RE: Oconee Nuclear Station
Docket Nos. 50-269, -270, -287

KEOWEE OVERHEAD EMERGENCY POWER PATH
SEISMIC QUALIFICATION AND ANALYSIS
REQUEST FOR ADDITIONAL INFORMATION

Figure 1

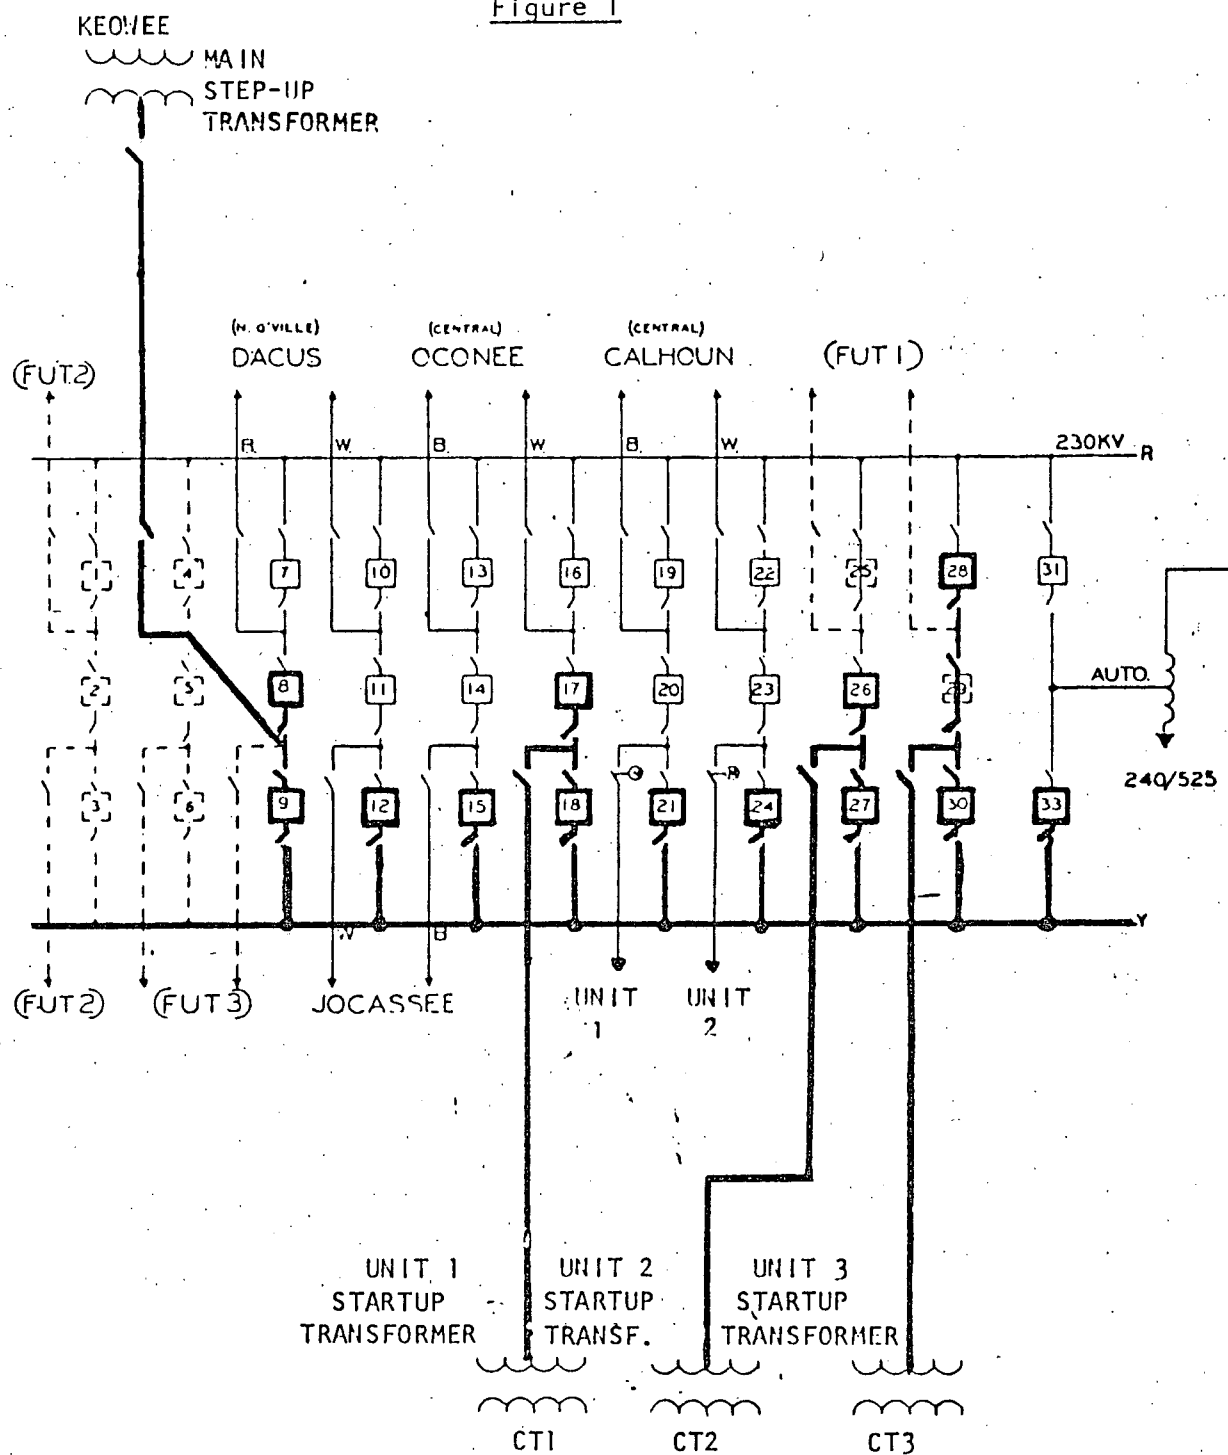
The Keowee Overhead Emergency Power Path is shown in bold lines on Figure I.
